# Presentation of ACSF C tests

Industry input to ACSF IG  
14<sup>th</sup> meeting  
August 2017, Köln

## 3.5.2. Abort of lane change test

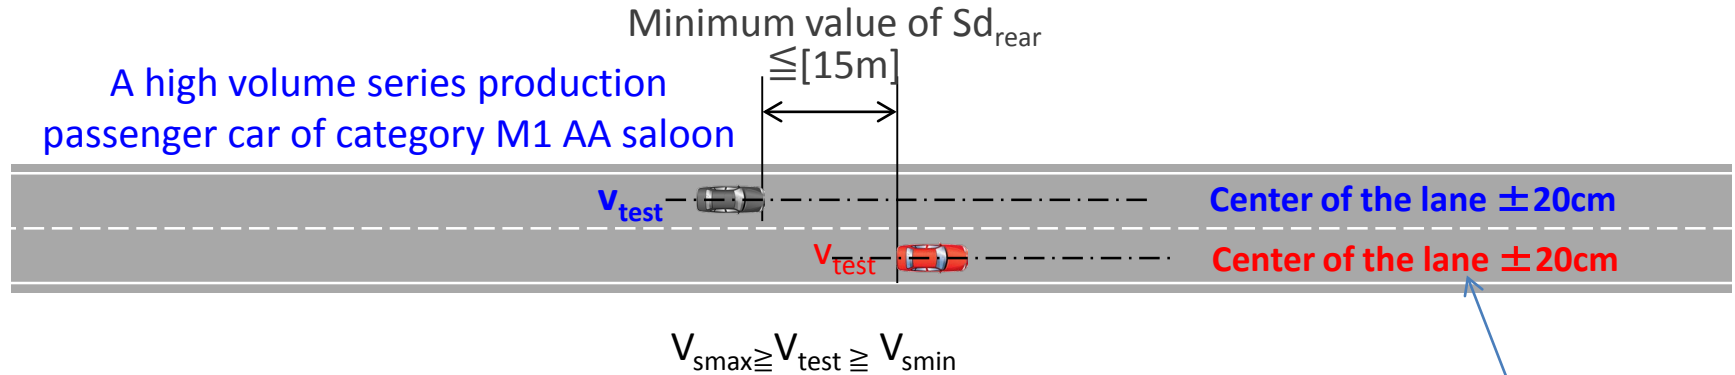
Is it needed?

- 1. The lane change procedure does not start.*
- or*
- 2. The lane change procedure is canceled no later than 10 seconds after the deliberate action of the driver, if the lane change procedure has started and the manoeuver is delayed. The driver is informed that the manoeuver is delayed.*

### 3.5.5. Sensor performance test

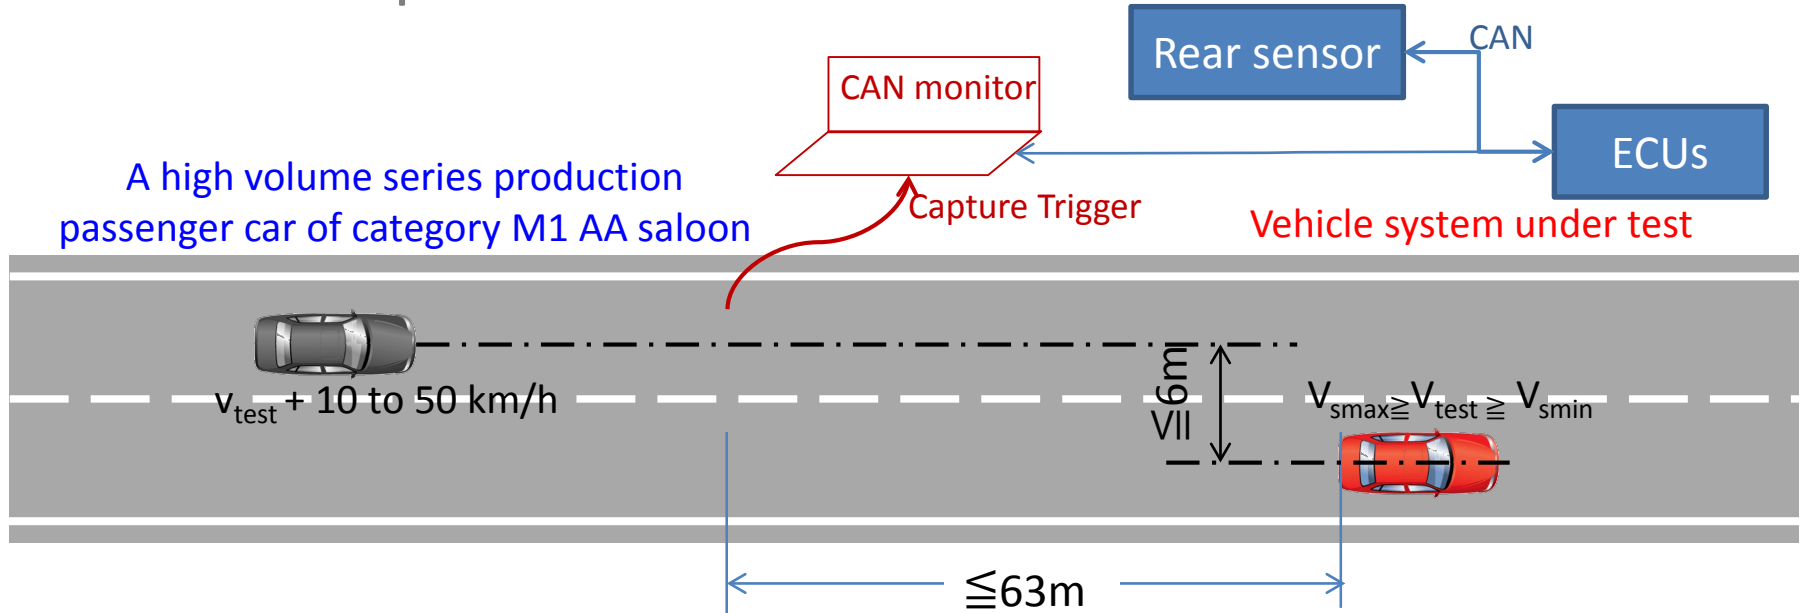
Capture the sensor data at the timing the rear vehicle is detected  
Confirm the actual distance to the rear by using GPS data of both vehicles  
**Connection of CAN monitor system should be allowed.**

**The test shall be repeated with a motorbike (L3), and the distance shall be set at 55m.**

## 3.5.6. Sensor blindness test

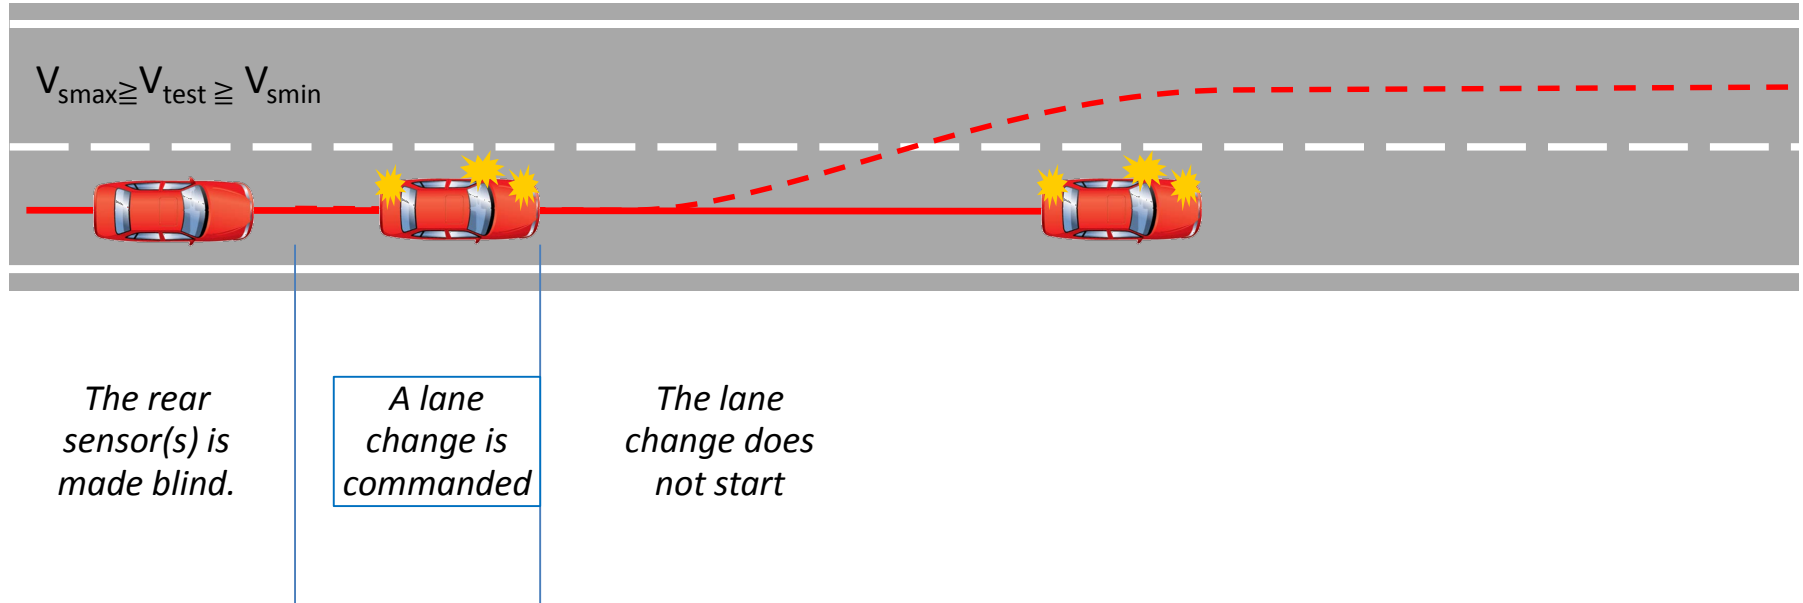
Extra-test proposed by industry
